Disability Access Report

Mixed-Use Development
38-40 Orth Street &
26 Somerset Street
KINGSWOOD NSW

For: Biogene Property Investment Pty Ltd
Ref: LP_19130

Figure 3 | Stairs from Somerset Street

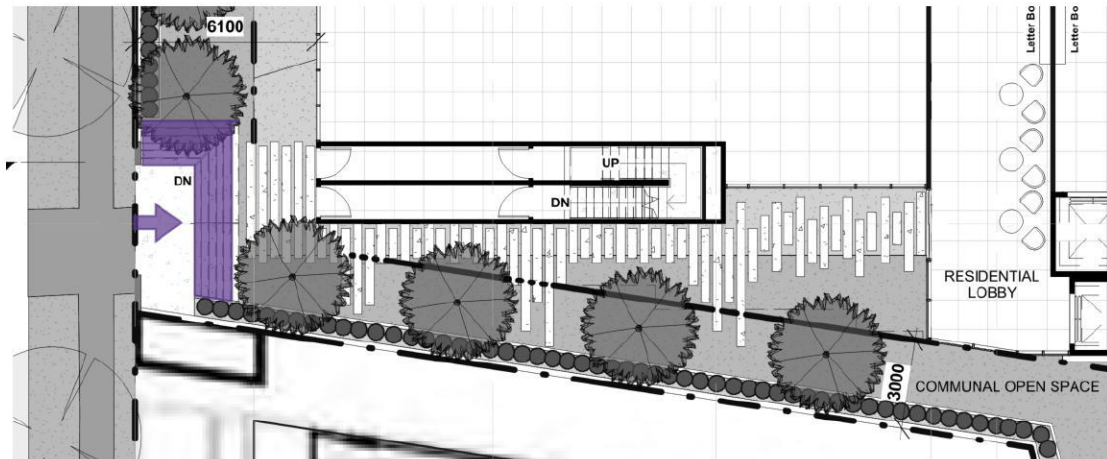
Stairs are provided as a part of the pedestrian access Somerset Street to the building. This does not constitute the principle pedestrian access to the site. AS1428.1 has access requirements for all public access stairs and is applicable in this instance.

- a. Stairs to comply with AS1428.1(2009), Clause 11.2.
- b. Where the stair intersects the property boundary, the stair shall be set back a minimum of 900mm so that handrail extensions and tactile indicators do not protrude into the traverse path of travel.
- c. Stairs to have closed or opaque risers. Open risers cause confusion for persons with a vision impairment and may trigger conditions such as epilepsy due to light penetrating through the open riser.

- d. Provide handrails, with extensions, to both sides of the stair (AS1428.1 (2009), Clause 11.2 & 12). Handrails to have an external diameter between 30-50mm to assist persons with a manual disability such as arthritis. Handrails are required on both sides of the stair to cater for left and right-handed disabilities. A central handrail is also an acceptable solution where adequate width is available. In this instance, the use of a double handrail is encouraged so that two users can travel in opposite directions and maintain their grip on the handrail.

- e. Stair nosings to have minimum 30% luminance contrast strip 50-75mm wide to the top of the stair tread to assist persons with a vision impairment. The strip can be set back 15mm from the edge of the riser.

- f. Stair nosings shall not project beyond the face of the riser.
- g. Provide tactile indicators at the top and bottom of the stair to comply with BCA Clause D3.8 and AS1428.4.
